ADDENDUM 1 (PENDING DSA APPROVAL)

PROJECT: **Santa Ana College**
 Science Center

DATE: 8/23/2017

DSA File No.: 30-C2
DSA Applications No.: 04-115788
HGA Commission No.: 3584-001-00

1 ENLARGED CANOPY ROOF PLAN
1/4" = 1'-0"

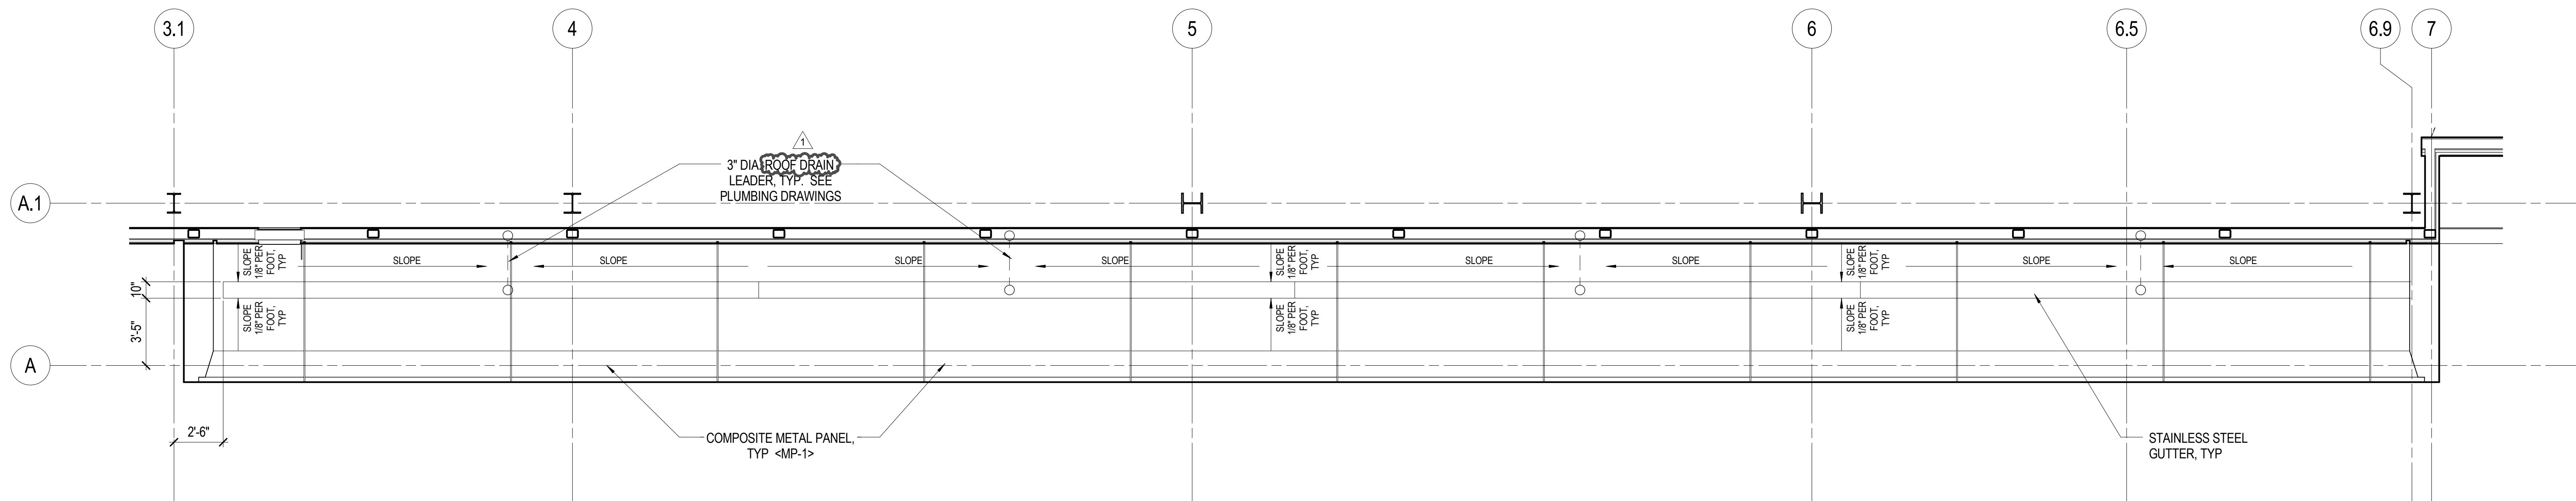
- North canopy reduced by 5'-0" at Detail 1.
- Gutter removed from roof at north canopy at Detail 1.
- Notes revised at Detail 2.

A301

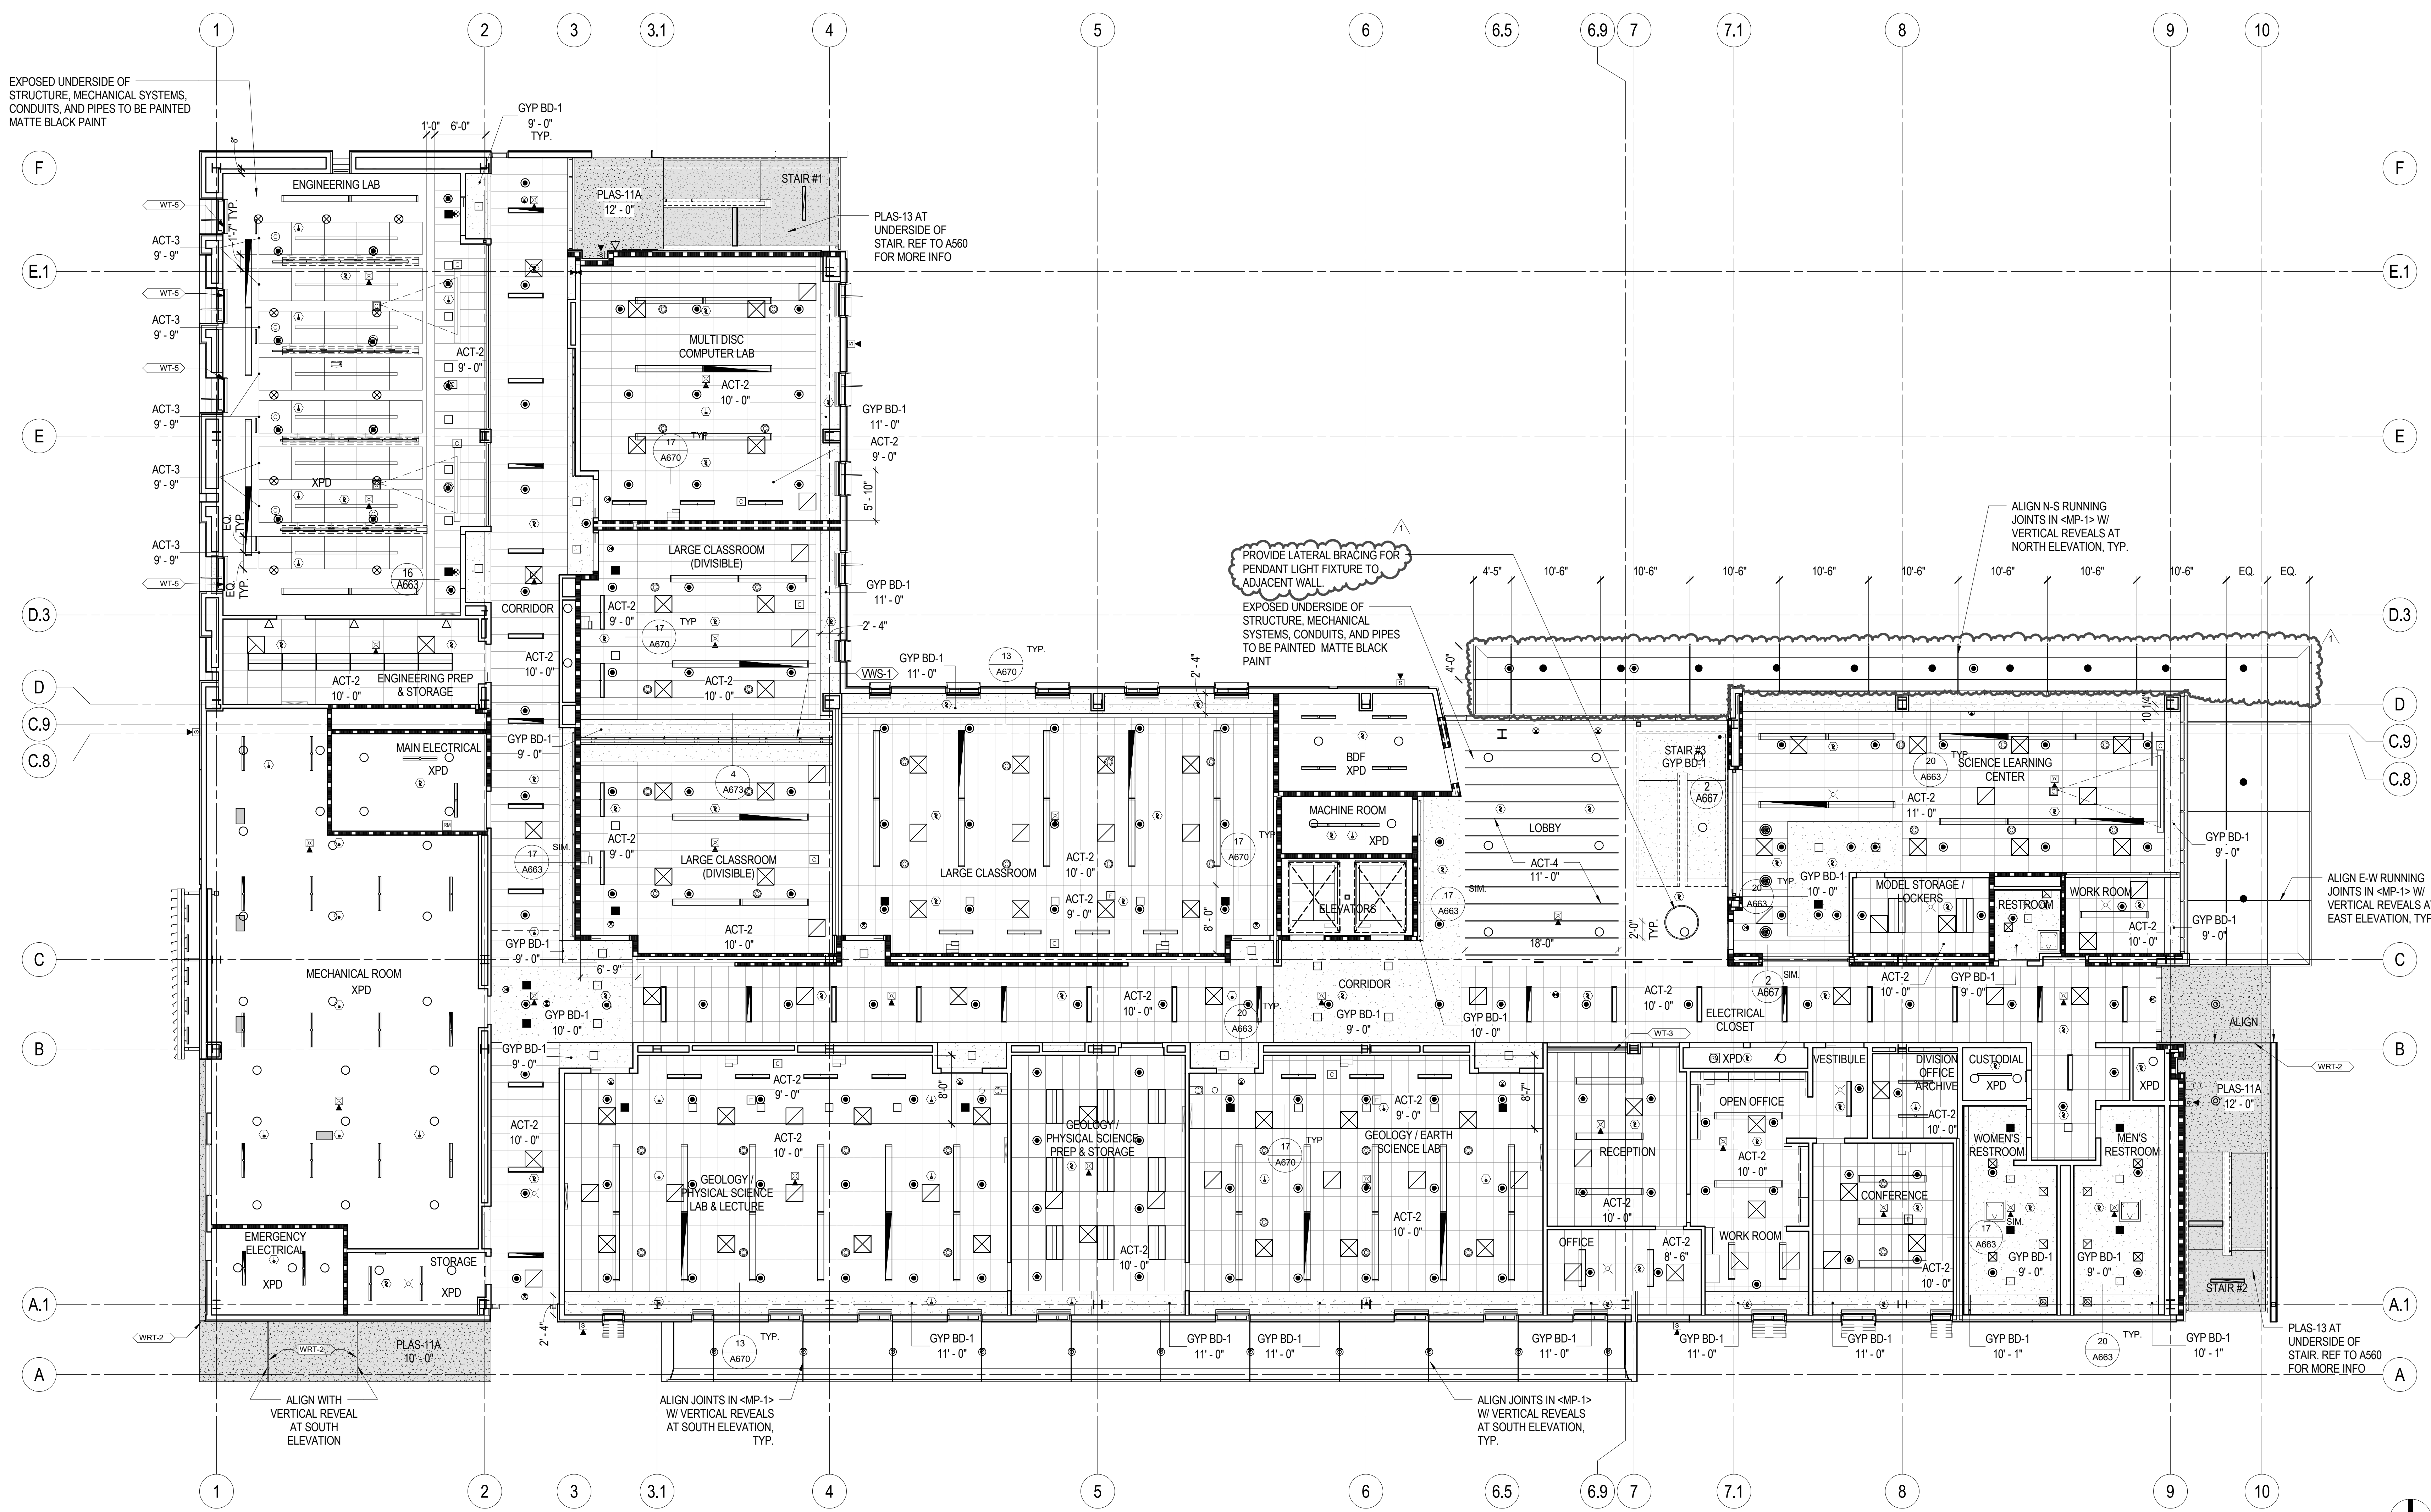
- North canopy reduced by 5'-0".
- Bracing clarified for pendant fixture outside of Science Learning center.
- Associated fire sprinklers, lighting fixture shifted south as a result.

A400

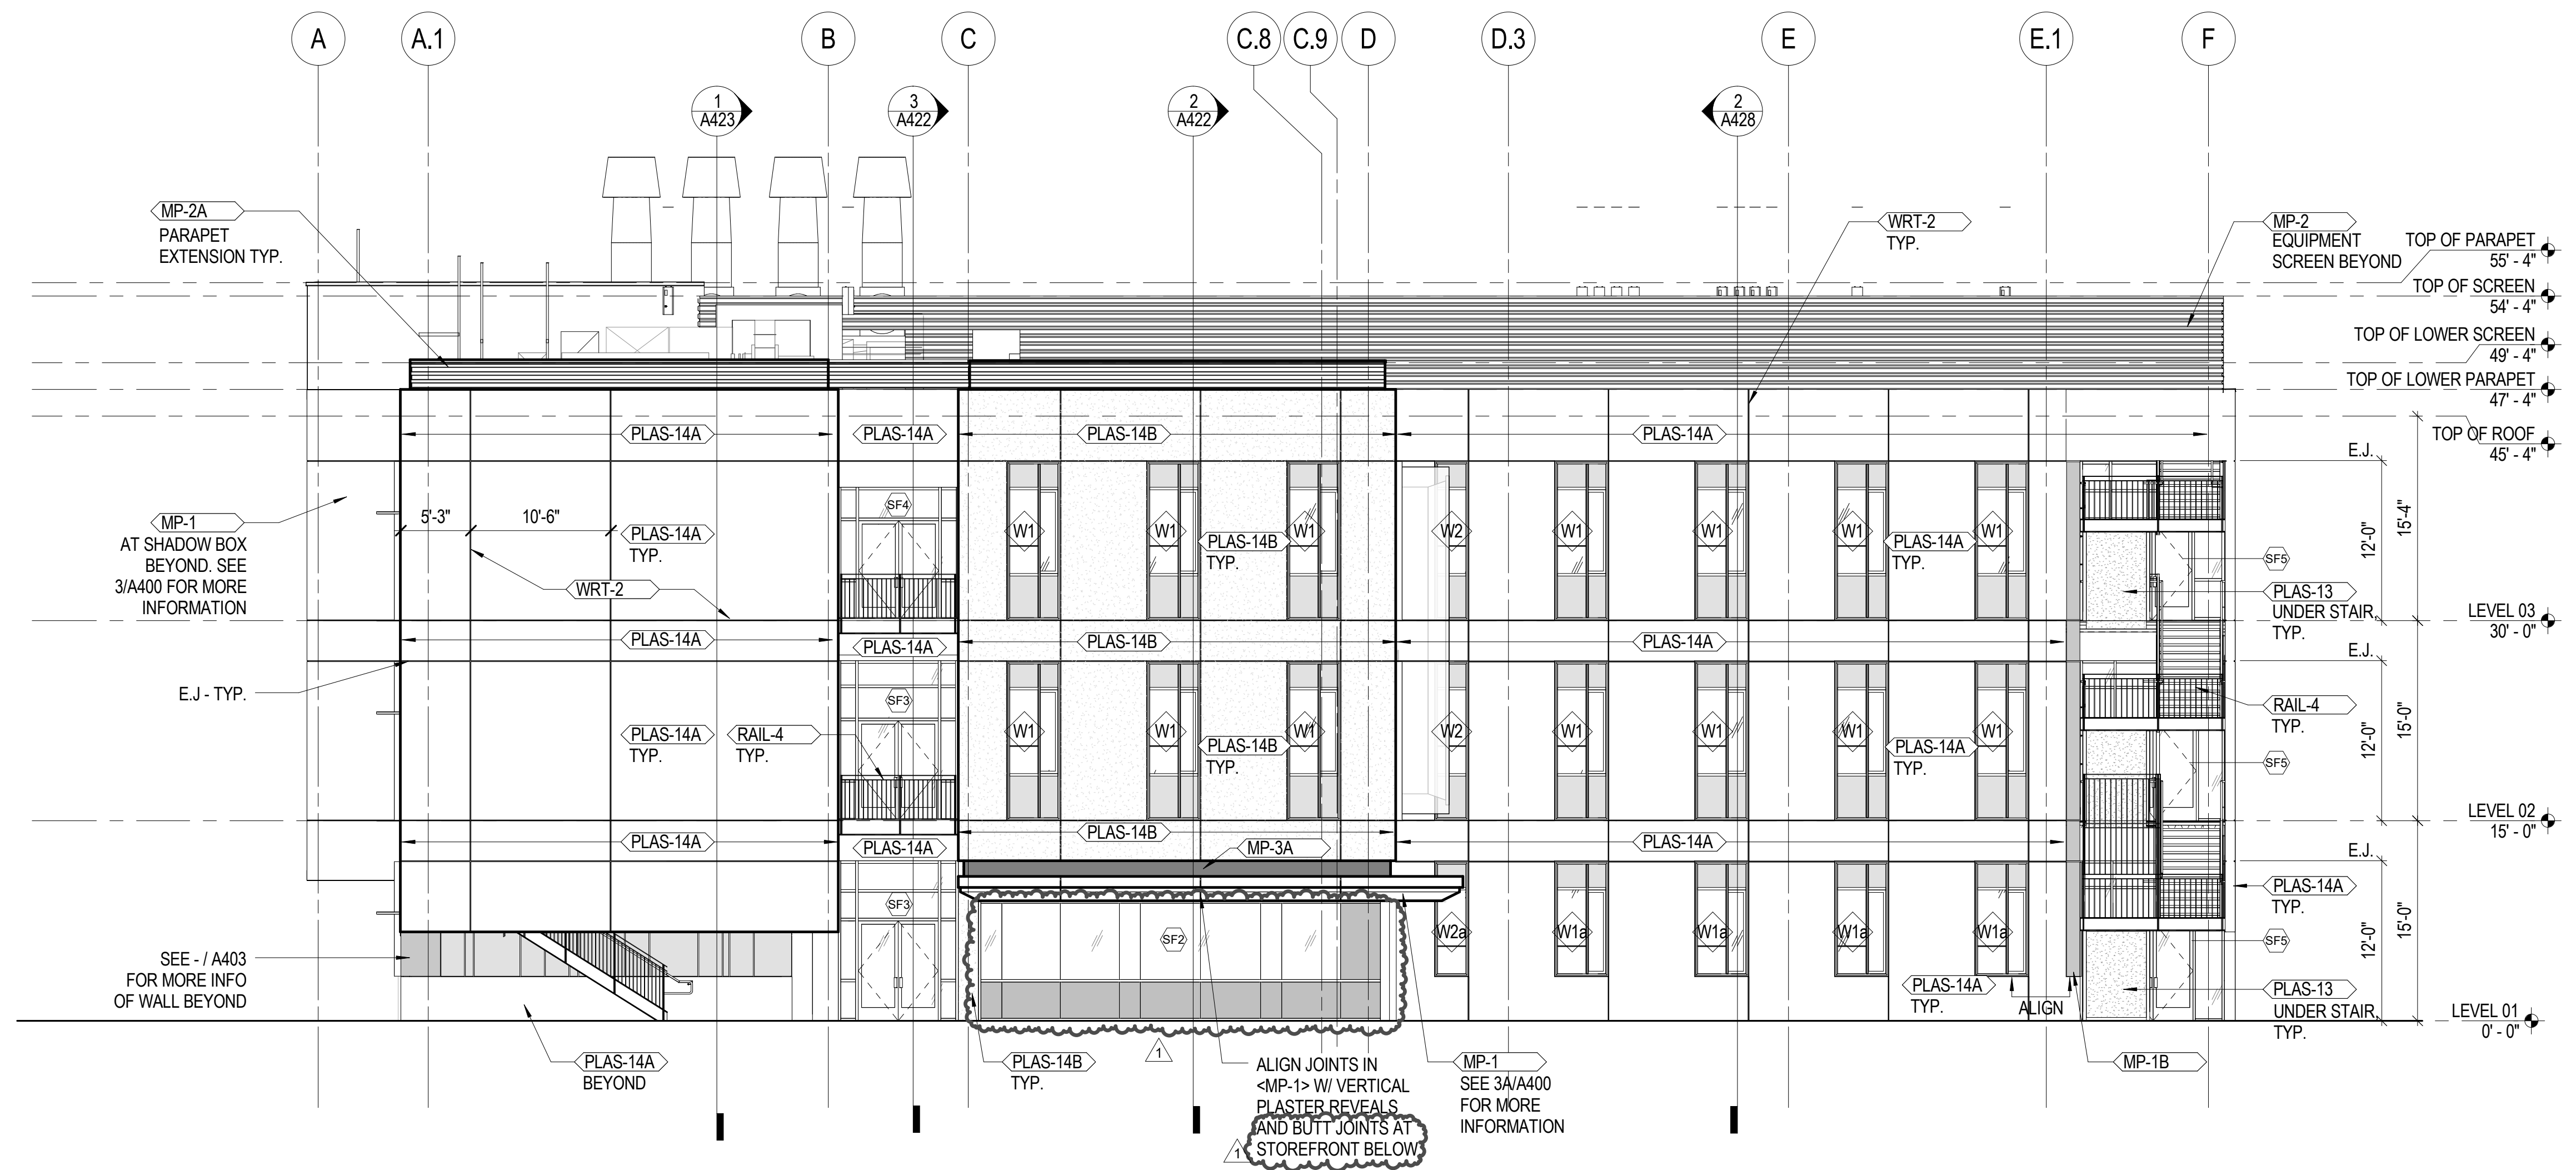
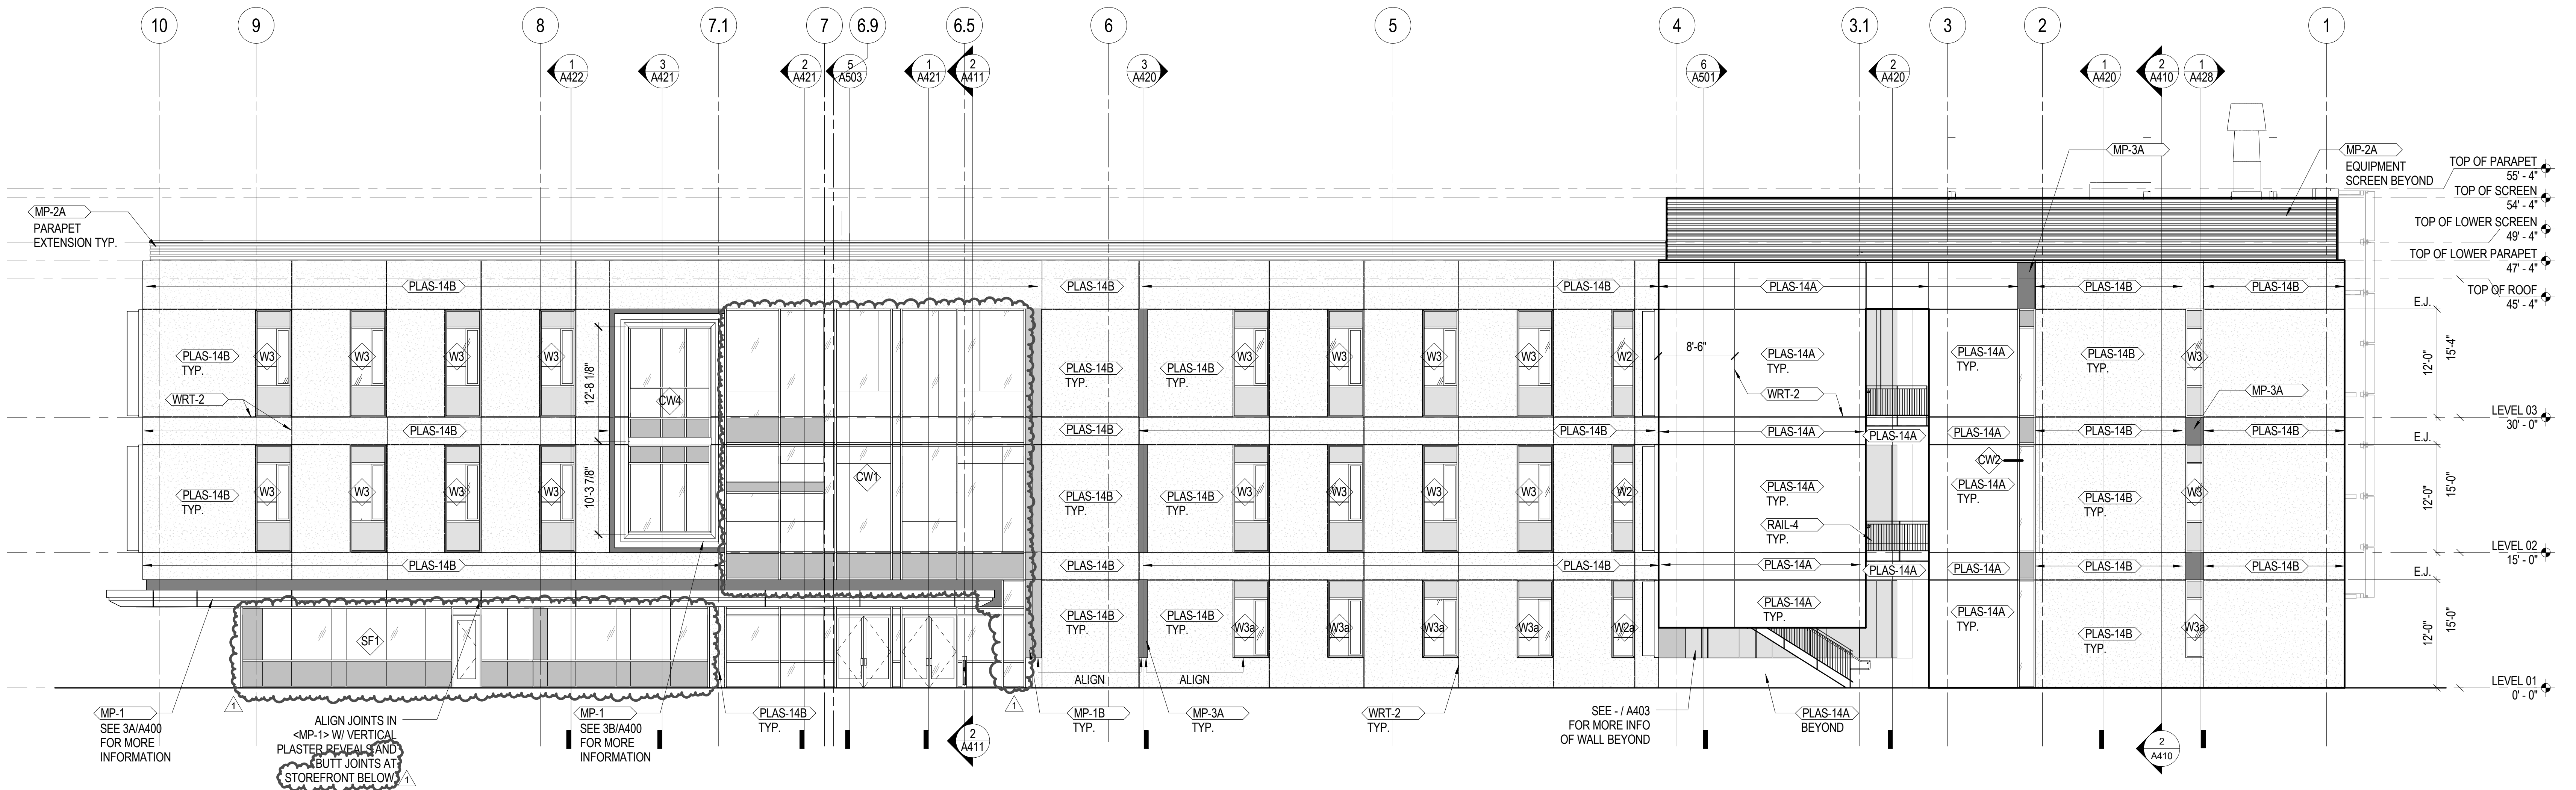
- Butt joints and glass type updated at storefront SF1 and Curtainwall CW1 at Details 1 and 2.
- Extended metal panel above entry canopy at Detail 1.
